Access Compliance Report

Public Rights-of-Way

Intersection ID: 10027413	Main Street: GOLF_LINKS_DR_N	Cross Street: N/A	Location: SW
ADA ID: 33F3C43B19E5	Ramp Type: Perp	Initial Pass/Fail: Fail	Overall Compliance: No
		Severity Score: 12.5

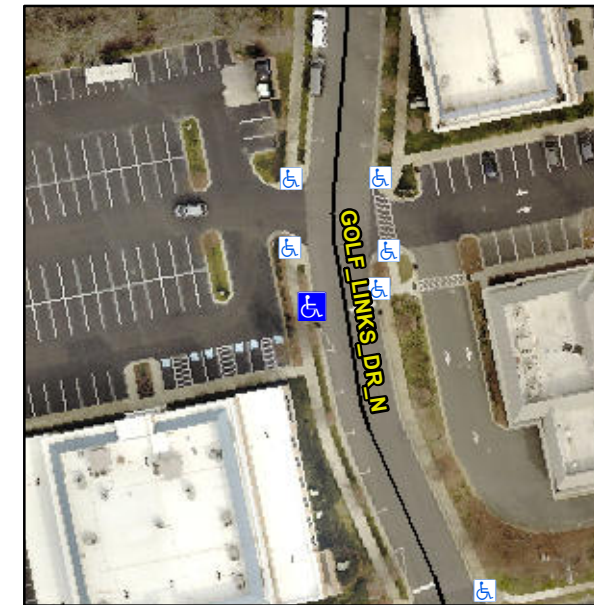
Not Found, R304.2.2

Compliance	Description	Data	Compliance	Description	Data
N/A	Ramp Length (in)	48.0	No	Ramp Slope (%)	10.7
Yes	Ramp Width (in)	60.0	Yes	Ramp XSlope (%)	0.7
N/A	Flare Type LT	N/A	N/A	Flare Type RT	N/A
N/A	Flare Slope LT (%)	N/A	N/A	Flare Slope RT (%)	N/A
N/A	Flare Traversable LT?	N/A	N/A	Flare Traversable RT?	N/A
N/A	Landing Length (in)	N/A	N/A	DWS Provided?	N/A
N/A	Landing Width (in)	N/A	N/A	DWS Contrast?	N/A
N/A	Landing Slope (%)	N/A	N/A	DWS Length (in)	N/A
N/A	Landing X Slope (%)	N/A	N/A	DWS Full Width?	N/A
N/A	Landing Curb? (Y/N)	N/A	N/A	DWS Offset (in)	N/A
N/A	Shared Landing?	N/A			
N/A	Gutter Ponding?	N/A	N/A	Gutter Slope (%)	N/A
N/A	Gutter Lip Ht (in)	N/A	N/A	Gutter X Slope (%)	N/A
N/A	Painted X Walk1?	No	N/A	Painted X Walk2?	N/A
	X Walk 1 Direction	To E		X Walk 2 Direction	N/A
N/A	X Walk 1 Width (in)	N/A	N/A	X Walk 2 Width (in)	N/A
	X Walk 1 Slope (%)	2.8		X Walk 2 Slope (%)	N/A
	X Walk 1 X Slope (%)	1.4		X Walk 2 X Slope (%)	N/A

Remove & Replace Entire Ramp.
